Report: TAB Report
Function: Test, Adjust, & Balance
Date: 03/12/2026
Completed By: National TAB

03-09-26 Culvers - Brooklyn, OH

Project: 03-09-26 Culvers - Brooklyn, OH

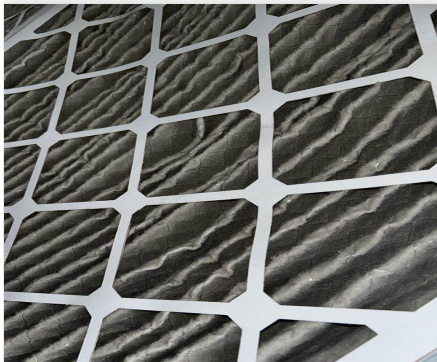
Issue Name : PRV-2 & PRV-3 missing grease cups
Description : Grease cups were not shipped with the units. Recommend requesting them from Accurex to prevent grease buildup on roof
Created By : National TAB **Assigned To :** National TAB - Brianna Biggs
Status : Open
Priority : Low **Asset Tag :**
Originated Date : 03/11/2026 - Aaron Cosby - National TAB

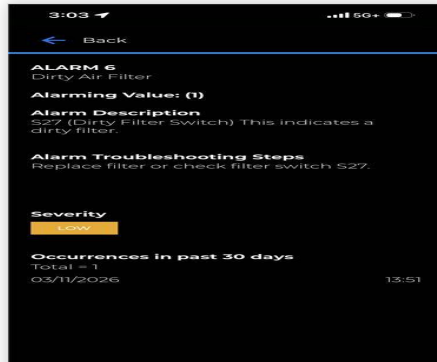
Issue Name : RTU-1 & RTU-2 dirty filters
Description : Filters were not changed after construction. Recommend replacing (12x 24"X24"X2")
Created By : National TAB **Assigned To :** National TAB - Brianna Biggs
Status : Open
Priority : Medium **Asset Tag :**
Originated Date : 03/11/2026 - Aaron Cosby - National TAB

- **03/12/2026 National TAB - Aaron Cosby**
 - Filters will be replaced 3/16/26 or 3/17/26

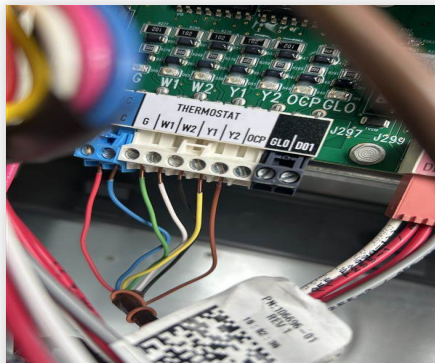
Issue Name : RTU-1 & RTU-2 missing occupancy wiring
Description : Both RTUs need thermostat wire run from OCP on each RTU to their respective Ec terminal. Without it, economizing will be disrupted and Humiditrol reheat will not operate. This will cause negative building pressure and compromise the unit's ability to remove moisture from the air. A jumper was temporarily installed during balancing
Created By : National TAB **Assigned To :** National TAB - Brianna Biggs
Status : Open
Priority : Medium **Asset Tag :**
Originated Date : 03/11/2026 - Aaron Cosby - National TAB
